STAFF RECOMMENDATION

1411 Holly Street

July 21, 2021

Application: New Construction—Addition

Figure 2 (left) shows the existing window opening and Figure 3 (right) shows the proposed door opening.

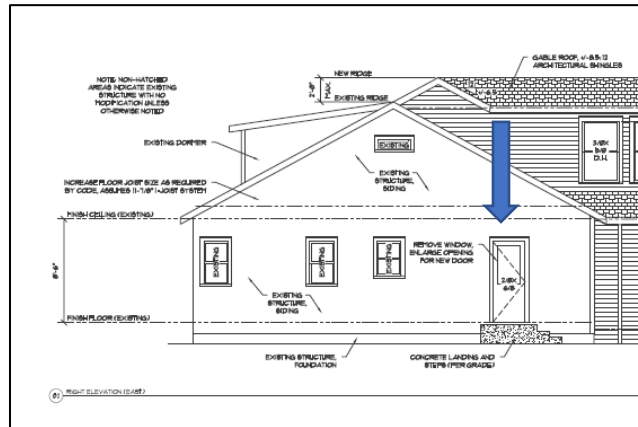
Partial Demolition: The applicant intends to alter the window openings on the side facades, which is considered partial demolition. On the right façade, the applicant intends to create a door opening out of an existing window opening (Figures 2 & 3). Staff finds this alteration to be appropriate because the window is at the back of the side façade and because the door opening will not be substantially larger or different than the existing opening.

Figure 4 (left) shows the existing window opening and Figure 5 (right) shows the proposed new opening.

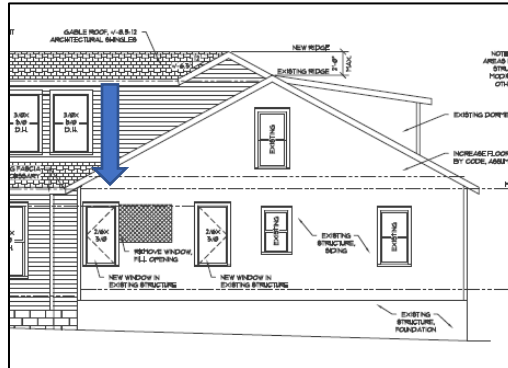
On the left side elevation, the applicant intends to remove a short paired window opening and replace it with a taller, vertical window opening (Figures 4 & 5). Staff finds this to be appropriate because the alteration to the window opening is at the rear of the side façade, the new window opening is an appropriate size and scale and there will still be an opening at this location.

01 SITE PLAN Scale: 1/16"=1'-0"

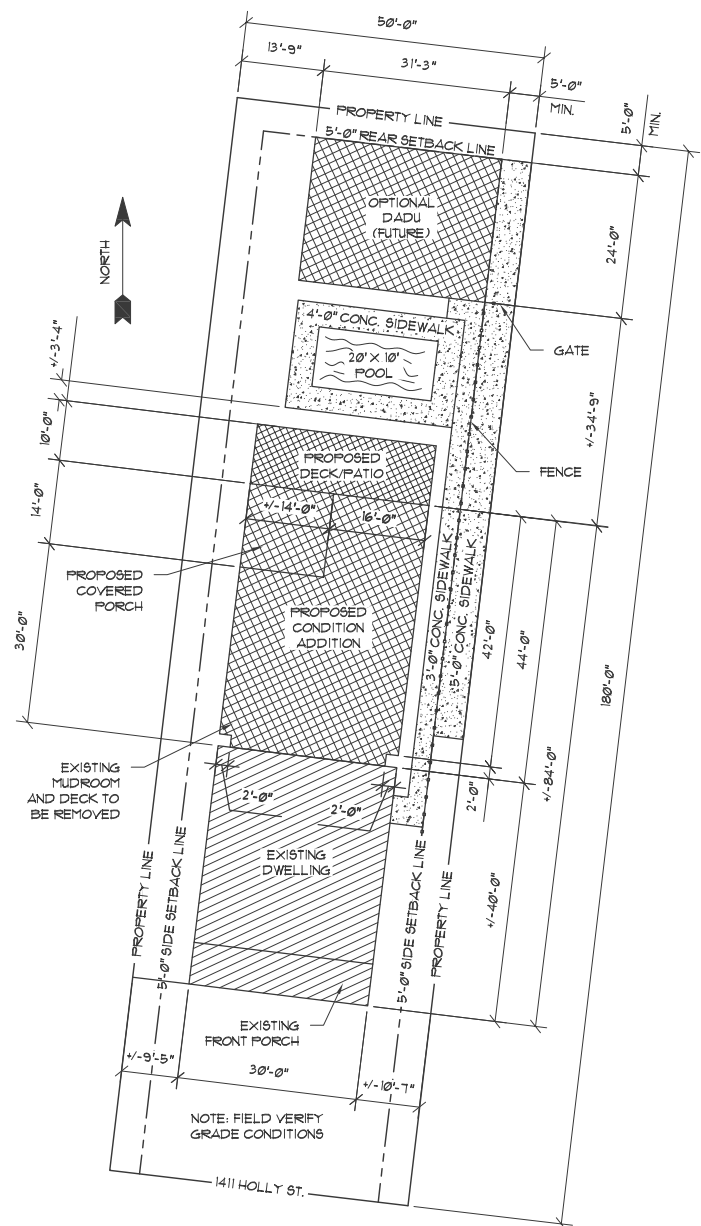
Siting and Setback: The addition meets all base zoning setbacks. It is at least five feet (5') from the right side property line, approximately nine feet (9) from the right side property line, and over sixty feet (60') from the rear property line.

Staff finds the proposed siting setbacks to meet Section VI.C. of Part I and the Lockeland Springs-East End chapter of Part II. of the consolidated design guidelines for the turn-of-the-century neighborhood conservation zoning overlays
